ITEM E4 – TERRA BELLA SUBDIVISION

KPB File # 2022-024

AGENDA ITEM E. NEW BUSINESS

KPB File No.	2022-024
Plat Committee Meeting:	April 11, 2022
Applicant / Owner:	Terra Bella Properties, LLC of Anchorage, Alaska
Surveyor:	Stephen Smith / Geovera, LLC
General Location:	West Fairview Avenue, City of Homer

TERRA BELLA SUBDIVISION

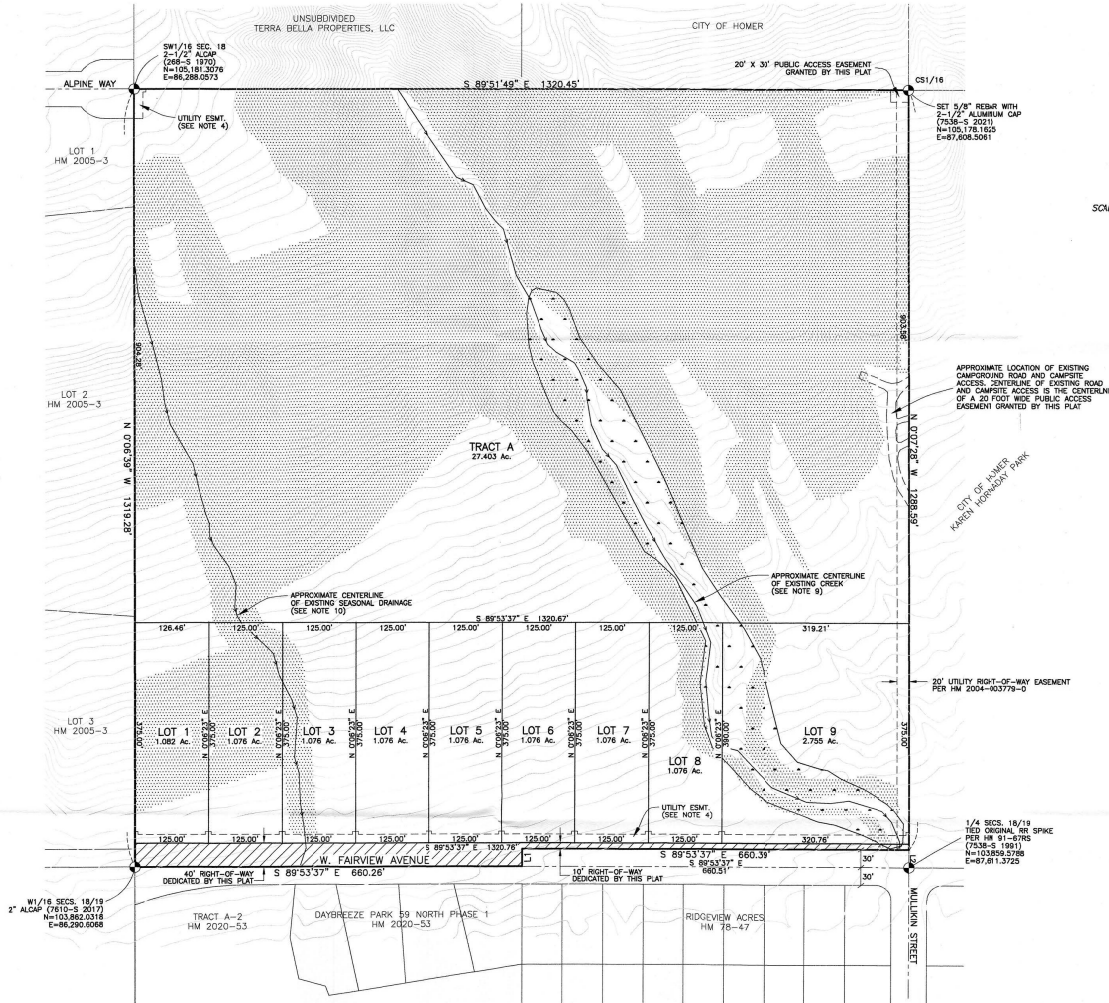
There are several easements granted by document per the Certificate to Plat. The surveyor stated in his letter that some should not be considered valid. **Staff recommends the owner work with the title company to remove items from the Certificate to Plat or add the appropriate plat notes.**

A 20 foot wide utility easement was granted along the eastern boundary by recorded document. The easement is depicted and labeled with the recording information. The Certificate to Plat mentions another easement by document HM 2004-003777-0. The location may be similar to the one being shown. **Staff recommends the location be determined and if differs from document HM 2004-003779-0 add to the plat, if the depiction is the same, add the recording number to the label.**

Staff recommendation: *Revise the title block by removing "A Portion" and add "excepting therefrom, Fairview Avenue according to Plat HM 88-52".*

- *We generally do not want ownership of neighboring lots as those may change. Remove "Terra Bella Properties, LLC" and "City of Homer" from lot designations and just provide "Unsubdivided".*

- *Staff would like for labeling to be consistent. The lots to the west only contain the recording number while those to the south have the subdivision name. Please either had the names to those to the west or remove on the southern lots.*

- *Provide Lot labels for the lots located south of W. Fairview Avenue.*
- *Located to the southwest is a preliminary plat that is being finalized in phases. Phase 1 has recorded and the lot should be labeled “Tract B1 HM 2022-07” and note the section line easement present for the southern portion of W Fairview Avenue. This will need to be reviewed prior to final. If Phase 2 records, it will change the Tract’s designation and W Fairview Avenue in addition to Eric Lane may be dedicated.*

- *Provide a width label for the portion of W Fairview Avenue located to the west of the subdivision and for the portion to the east.*
- *Provide width labels for Mullikin Street and Alpine Way.*

- *Per the Certificate to Plat, there is an easement for the existing water main along Fairview Avenue. The exhibit was not recorded with the easement but it appears to be within the area of Fairview Avenue. A plat note should be added, as this is on the Certificate to Plat. If the City of Homer agrees that the location will now be fully within the dedicated right of way, add to the plat note "the easement is no longer required with the dedication of W. Fairview Avenue." The other option is to work with the city to get the easement removed from the Certificate to Plat.*

REVISED Terra Bella Subdivision Preliminary Plat

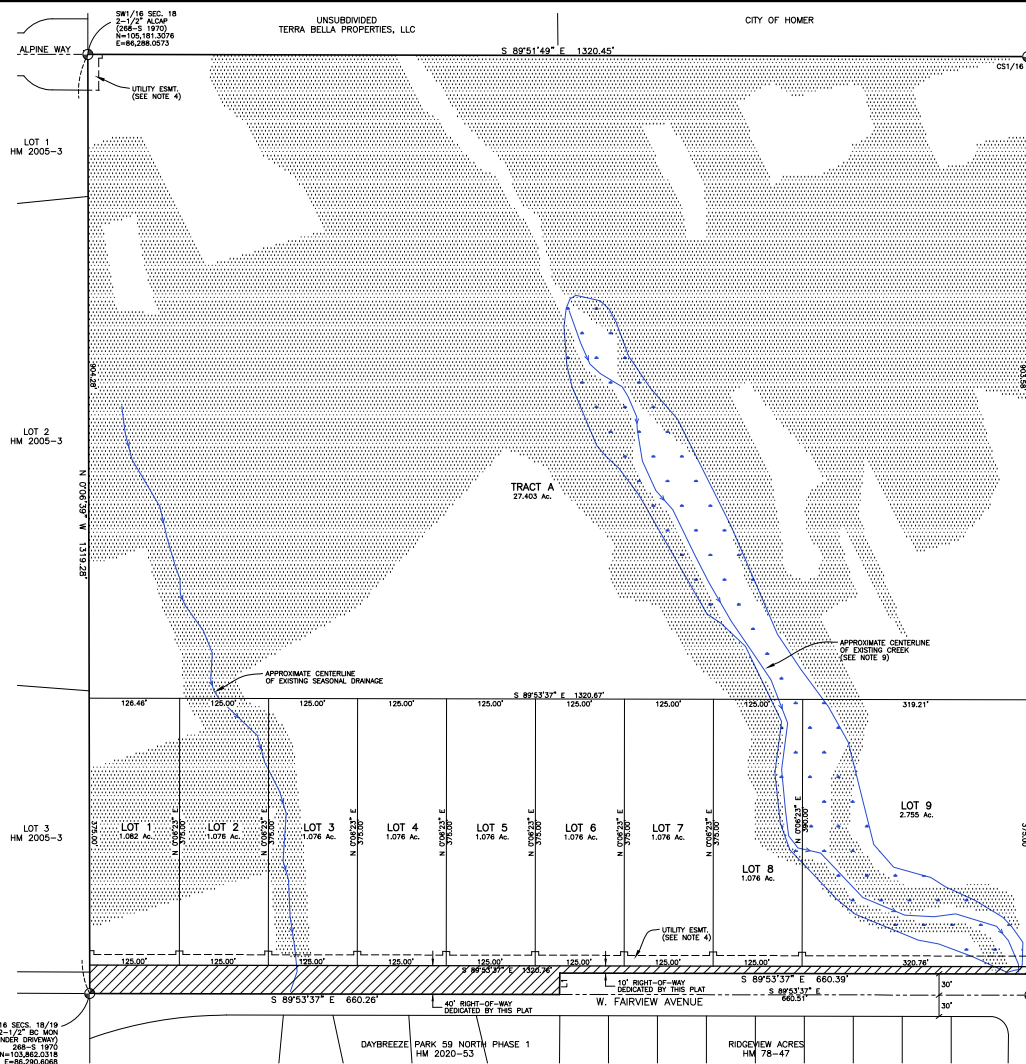
1. DEDICATE A PUBLIC ACCESS EASEMENT OVER THE EXISTING CAMPGROUND ROAD WHERE IT ENCROACHES ON TRACT A
2. GRANT A PUBLIC ACCESS OR TRAIL EASEMENT FROM THE NORTHWEST CORNER OF KAREN HORNADAY PARK TO THE CITY PARCEL
3. CORRECT PLAT NOTE 6 TO SPECIFY WHICH LOTS HAVE ACCESS TO CITY WATER AND SEWER
4. DEDICATE A 60 FOOT DRAINAGE EASEMENT CENTERED ON THE EASTERN CREEK.
5. ACCEPT A 40 FOOT DRAINAGE EASEMENT ON THE WESTERN CREEK AS SHOWN ON THE PLAT (TO BE PROVIDED AS A LAYDOWN AT THE MEETING.)

Staff Response: A 60 foot drainage easement is requested, 30 feet each side of the centerline of the eastern creek, extending north to the lot line.

Staff Response: The plat does not meet these requirements. Recommend dedication of a public access easement over the existing campground road where it encroaches on Tract A.

1. Drainage Easement: Request a 60 foot Drainage Easement for the eastern creek. A majority of the stream's riparian wetlands are in the flood plain east of the stream, so a wider easement will protect more of these wetlands.
2. Publics Works requested and received a 40' foot drainage easement for the western drainage. A revised plat with the new easement shown will be provided in the meeting laydown packet.
3. An installation agreement or subdivision development agreement is required.

Here is the revised Terra Bella Subdivision preliminary plat. The road has been redesigned to address the concerns of the downhill property owners. The revised road design actually improves the access to the two lots with existing driveways on the south side of the road. In order to accommodate lowering the road, the right-of-way on the north side has been revised to dedicate 40 feet instead of 30 due to the backslopes catching farther out. This will also help fit a sidewalk in at some point in the future.

The upper lot was eliminated so that legal access to Tract A can be by way of Alpine Way. The lot configurations were pared down from 130 feet by 390 feet to 125 feet by 375 feet. This was so that a little more room was available for a building site in the southwest corner of what is now Lot 9. Original Lot 10 was eliminated as well because access to a building site would have been across the deep drainage. We felt that it would be best to stay out of that drainage altogether in the development plan.
